Evaluation of necessary changes to Unit 1 Technical Specifications as identified by page number.

NORTH ANNA - UNIT 1

Figure 3.4-2 *Reactor Coolant System Temperature-Pressure Heatup Limitations*  
 North Anna Power Station No. 1—Reactor-Coolant-System-Heatup  
 Limitations—Applicable to 5 Effective Full-Power Years and Contains  
 Margins of 10°F and 60 PSIG for Possible Instrument Errors

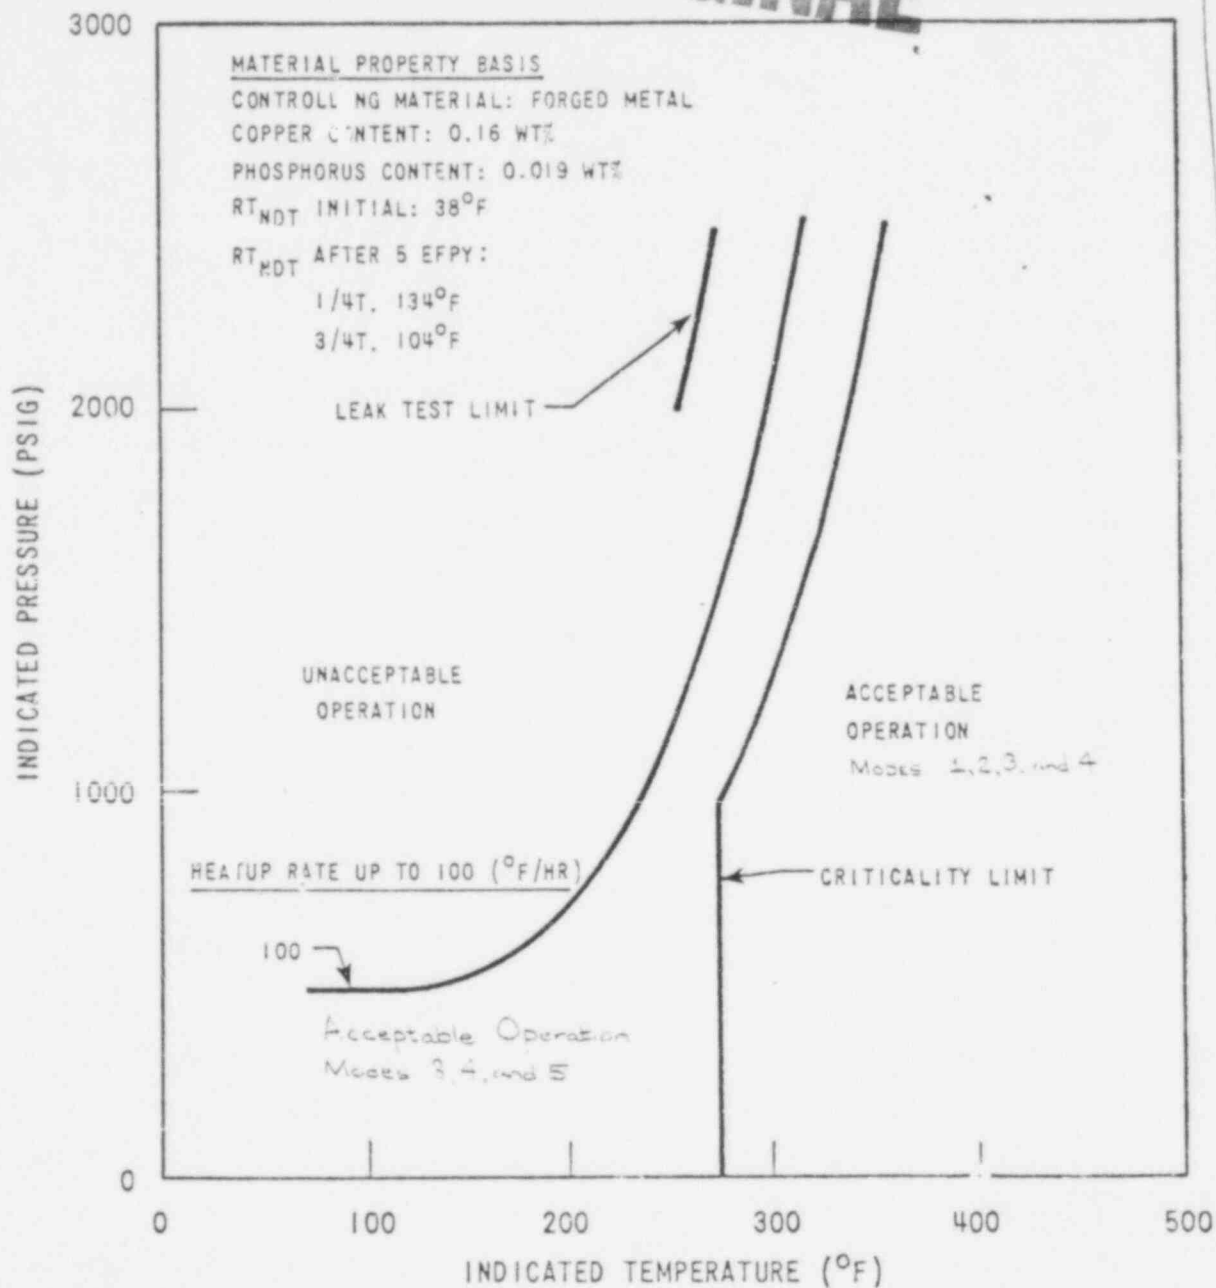
Page 3/4 4-26*	Update figures for heatup and cooldown curves to agree with figures previously submitted as part of the overpressure protection review. Similar to Unit 2, limits for hydrostatic testing are included.
4-27*	
4-28*	
Page 3/4 4-29*	Reactor vessel material irradiation surveillance schedule needs revision to be consistent with Unit 2 specifications and WCAP-8771.
Page 3/4 4-30a*	Add a new overpressure protection specification and basis for unit which is identical to Unit 2 except for setpoints.
4-30b*	
5-3*	
5-6*	
Page 3/4 6-33	The typo "Volume" should be corrected.
Page 3/4 6-35	The entire surveillance requirement should be changed to agree with the proposed Unit 2 requirement, since the hardware is the same equipment for both Units 1 and 2.
6-36
